**NOTICE
OSHTEMO CHARTER TOWNSHIP
PLANNING COMMISSION**

**THURSDAY, SEPTEMBER 30, 2021
6:00 P.M.**

To: Oshtemo Township Planning Commission

Request: Site Plan and Special Use request to amend an existing Planned Unit Development (PUD) to eliminate Unit 22 in order to enlarge Units 19, 20, and 21 in Phase I of West Port Village.

West Port Village – Replat No. 5

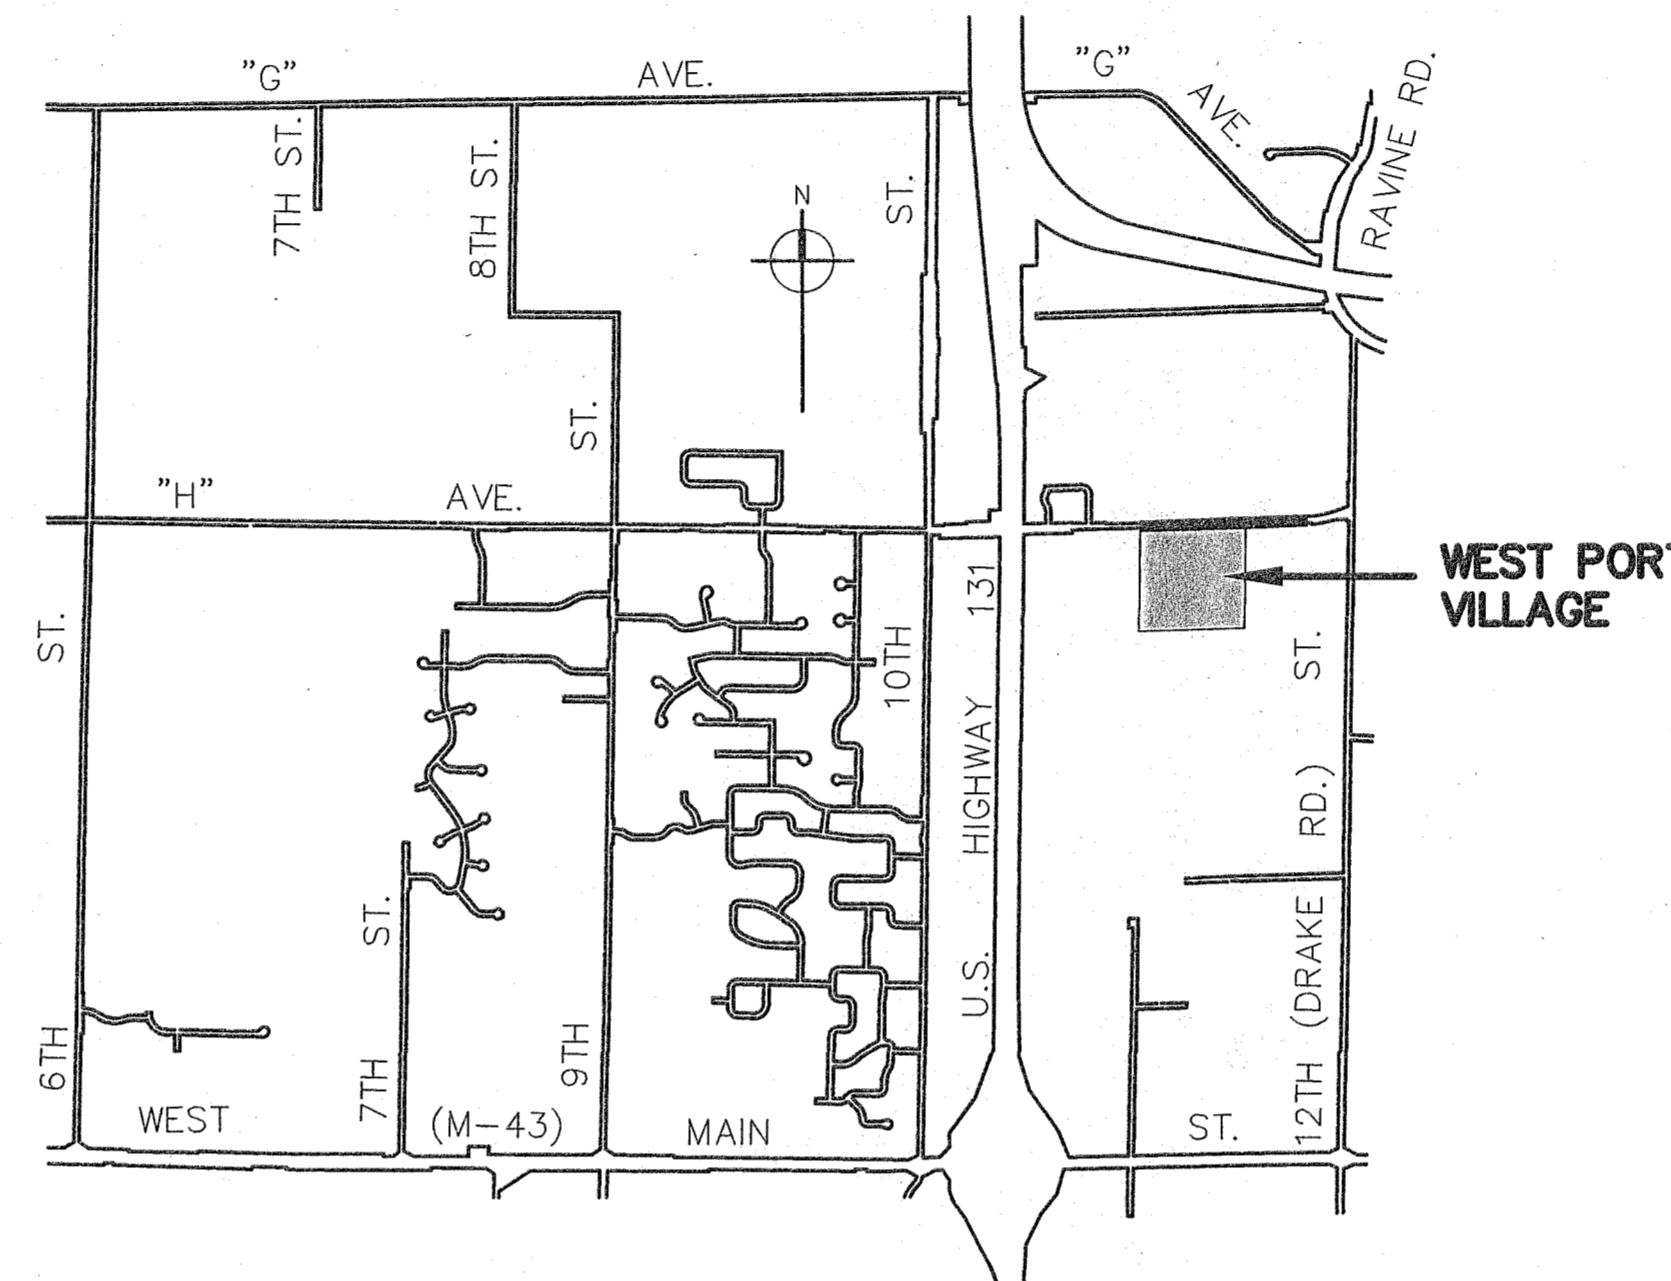
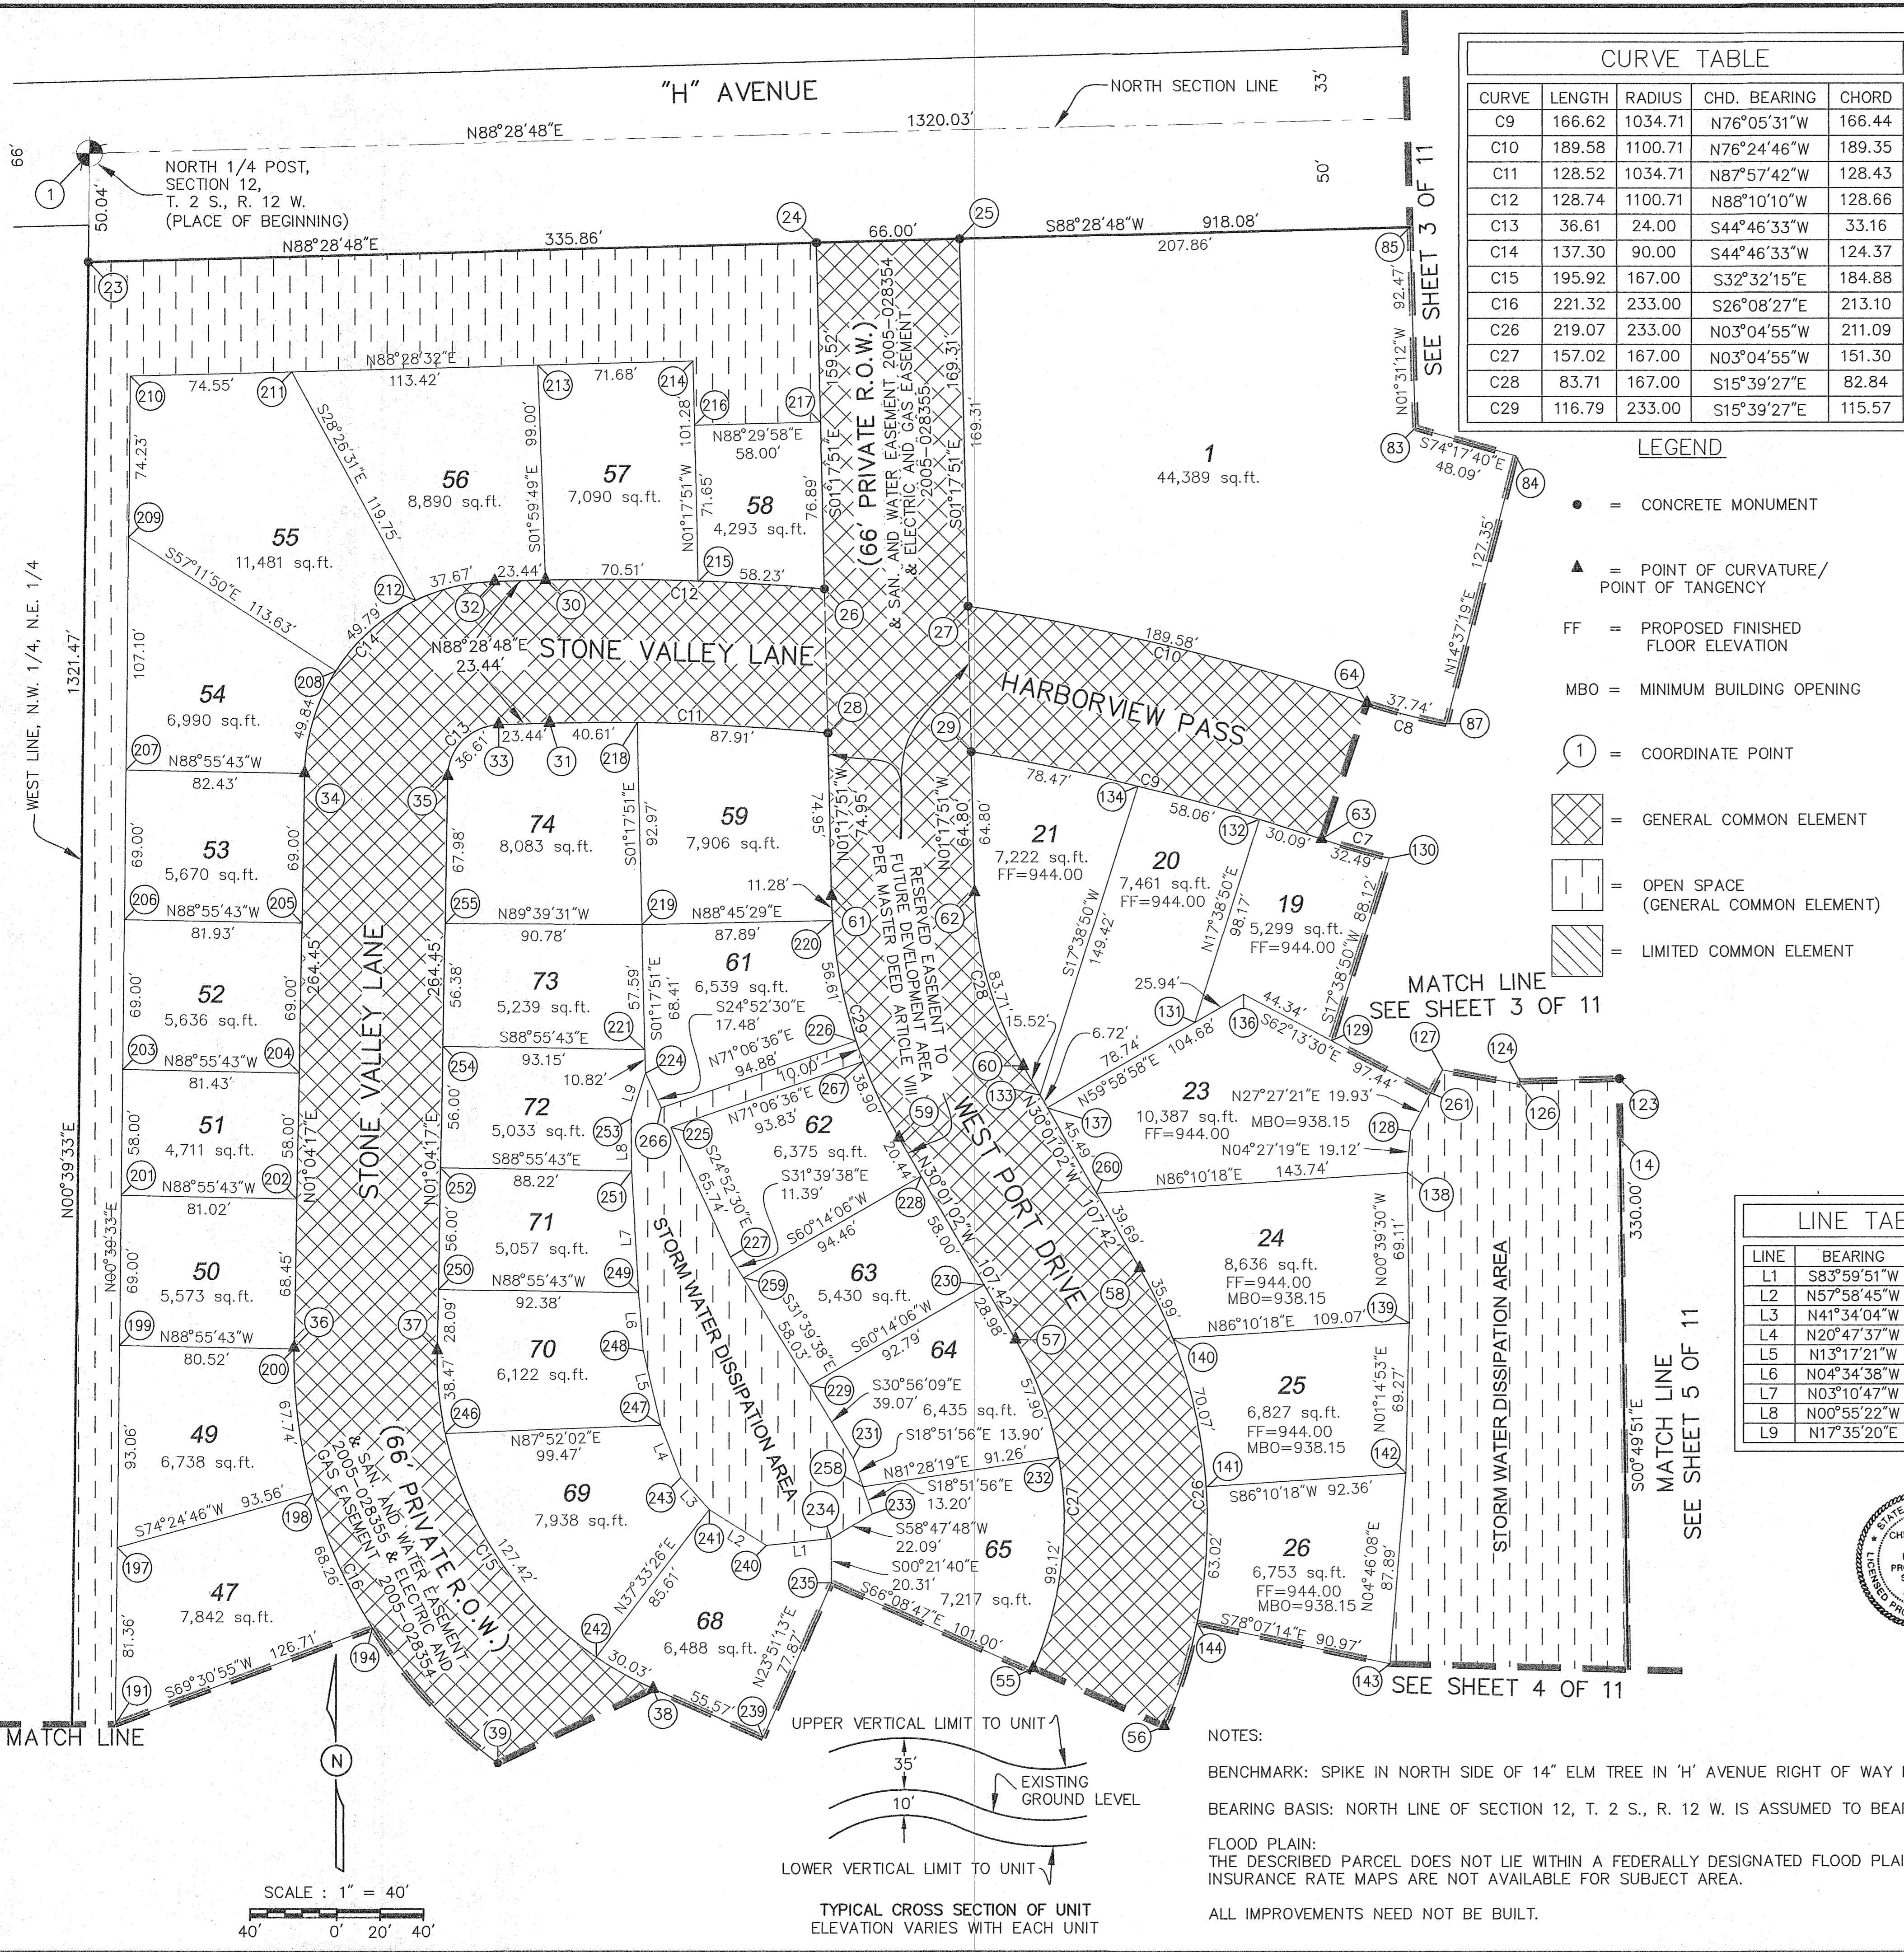
- 1) An updated Master Deed and Bylaws shall be provided for review by Staff and the Township Attorney and recorded.
- 2) An updated site plan providing a vicinity map on the Cover Sheet to display the current zoning of the site and the zoning districts surrounding the site.
- 3) An updated site plan providing the percentage of land reserved for open space and the percentage of land covered by buildings.
- 4) An updated site plan providing building setback information for the development as well as illustrating all setback measurements from the development's north, south, east, and west boundary lines.

- 5) An updated site plan adding pavement width measurements for all circulation aisles within the site as well as providing the location of existing and proposed sidewalk throughout Phases I and II.
- 6) Provide an additional page to the site plan which captures both Phases I and II on one sheet.
